Engineering Change Notice

Date	2025/03/19	Document No.	IECN-6353-2503
Model name	VDX-6353RD / VDX-6353RD-512		
Subject	Product revision,		
	P/N changes to VDX-6353RD-V2 and VDX-6353RD-V2-512

Difference

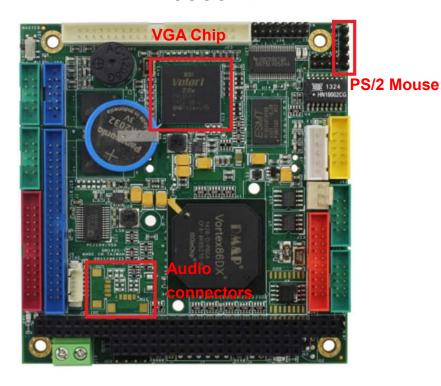
Due to the longevity issue of Z9s VGA chipset on VDX-6353RD, ICOP has introduced an alternative solution, VDX-6353RD-V2, which integrates a new VGA chipset solution called SM712 to replace it. Such changes will affect the customer who is currently using LCD panel and the platform OS that requires VGA driver to support. More information will be clarified in the content below.

- 1. BIOS version is different due to the change of VGA chip with following conditions.
 - 1) For customer who only requires VGA output, the new standard BIOS will work for you right away.
 - 2) For customer who is using LCD panel, the new LCD panel support BIOS is required to verify.
- 2. VGA driver is different due to the change of VGA chip. OS which is working under VESA mode is not affected.
- 3. PS/2 Keyboard and Mouse connectors position
- 4. Audio connecters position (optional)
